April 11, 2023

Re: Traffic safety measures at crosswalk at 6th and E Streets SE (at stop sign south of E Street)

Photos below of utility hole in crosswalk

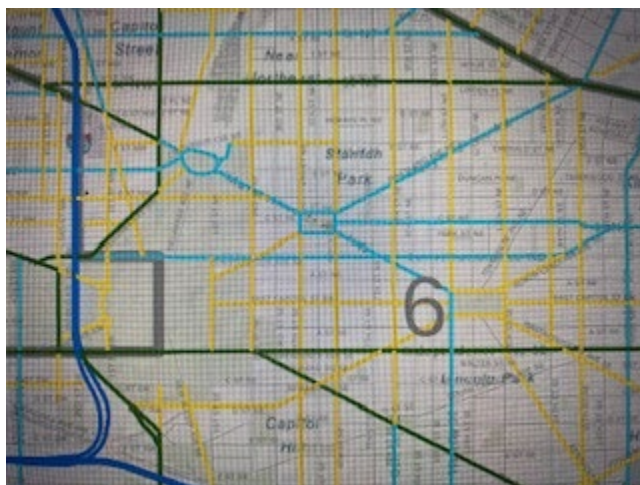
1. 6th Street SE is a "collector" road requiring addition traffic study before a raised crosswalk could be installed; and
2. There is a utility hole within the crosswalk that would impede the installation of a raised crosswalk.

We believe the reasons above are insufficient to install a raised crosswalk at the wrong part of the intersection. First, in examining DDOT's own [Functional Street Map with classifications](#), we see that East Capitol Street on both the north and south sides of Lincoln Park is marked in yellow as a collector street. There are several raised crosswalks in both the easterly and westerly directions of those streets. Second, the utility hole overlaps the north side of the crosswalk at the stop sign on 6th Street by a mere eleven inches (see photo).

Everyone deserves to be safe, and as we have recently learned, Vision Zero is not working well. We respectfully request that DDOT engage in the mandated traffic study to install a raised crosswalk in the most dangerous crossing of this intersection. Please do not waste money installing one where it is not needed.
